# **MONITORING YEAR 1 ANNUAL REPORT**

## **BANNER FARM MITIGATION SITE**

RE: **Banner Farm Draft MY1 Report Review  
French Broad River Basin – CU# 06010105  
Henderson County  
DMS Project ID No. 100062  
Contract # 7530**

Wildlands Engineering, Inc. (WEI) has reviewed the Division of Mitigation Services (DMS) comments from the Draft MY1 Monitoring report for the Banner Farm Mitigation Site provided in bold type below and offers the following responses in italics.

Figure 1 Current Condition Plan View Map (Key)  
 Banner Farm Mitigation Site  
 DMS Project No. 100062  
 Monitoring Year 1 - 2022  
 Henderson County, NC

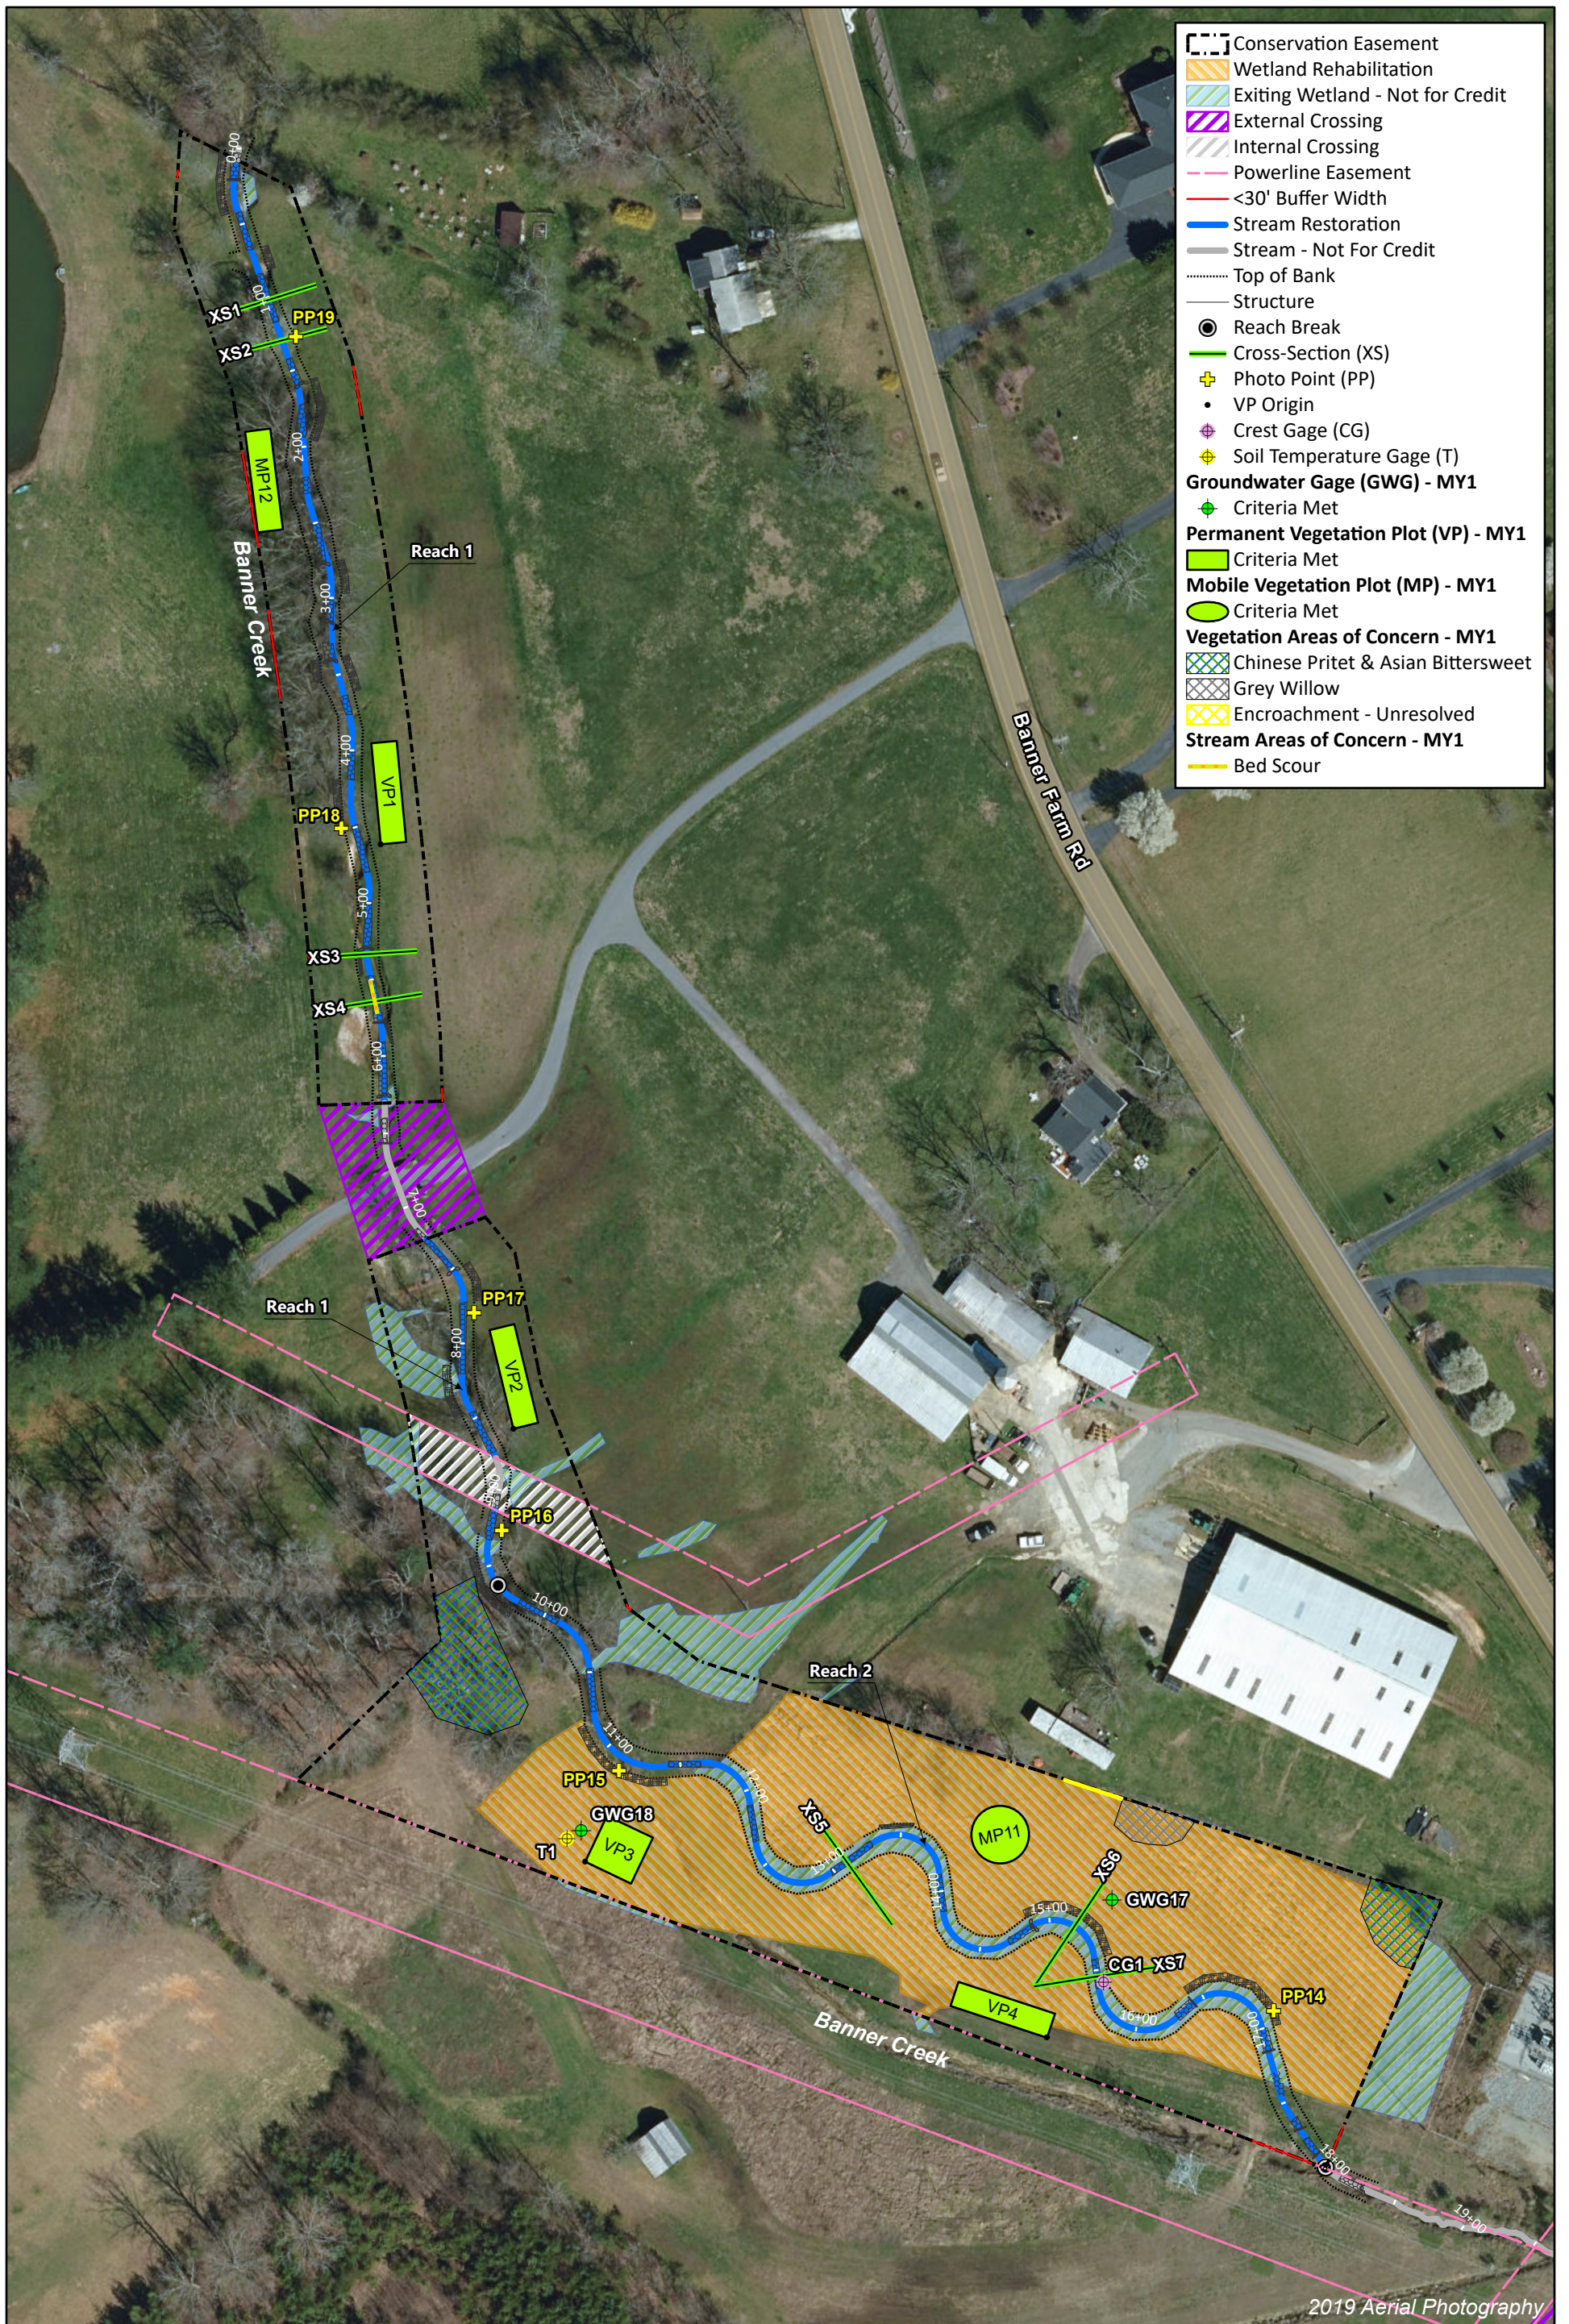
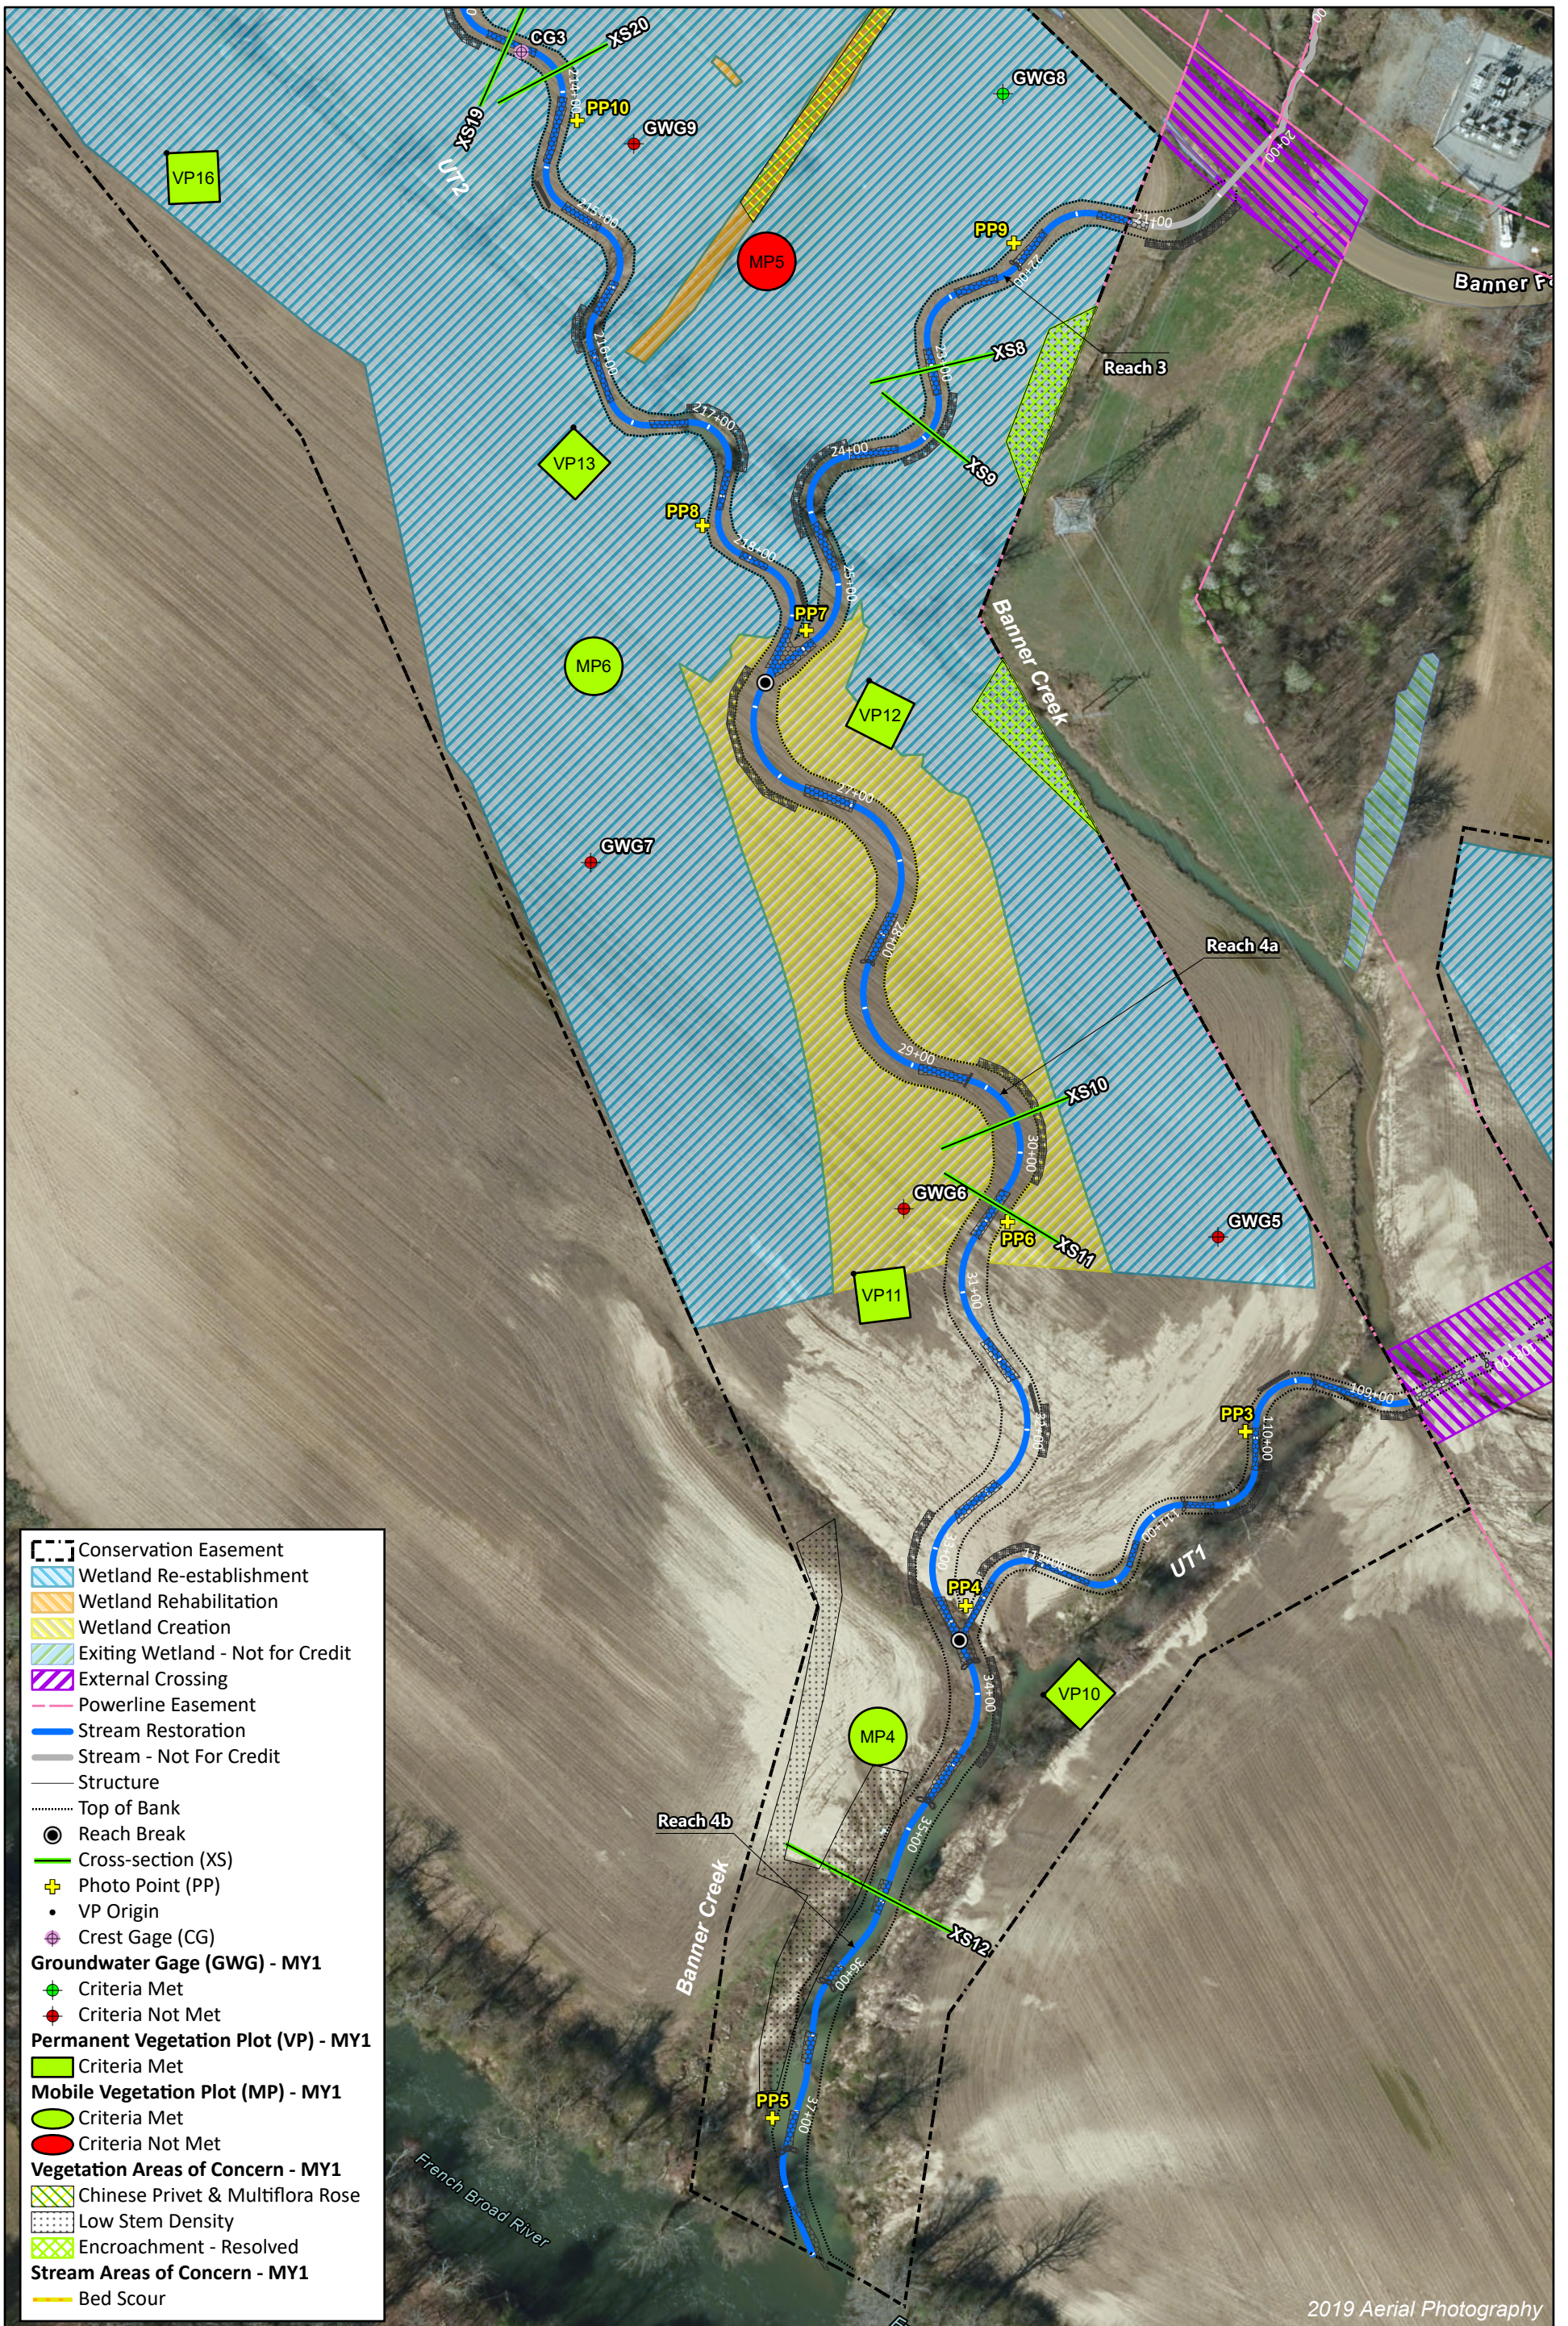
**Easement Encroachments: Discussion on easement encroachments is unclear. Two encroachments are discussed in section 2.5.1 Vegetation, and additional encroachments are discussed in section 2.5.3 Conservation Easement. The CCPV shows two encroachments. The first is on Banner Creek R2 (Fig 1a) and a second encroachment near the beginning of UT2 (Fig 1e). The two encroachments mentioned in 2.5.1 are not shown on the CCPV as encroachments, but they are shown as low stem density. Recommend showing all encroachments on CCPV and discussing in more detail in section 2.5.3 regarding location and description of each encroachment. A table or list would be helpful.**

*Wildlands Response: Discussion of the specific easement encroachment locations along with a summary table have been added to section 2.5.3. The resolved and unresolved encroachments that are discussed in the report have been added to the CCPV figures.*
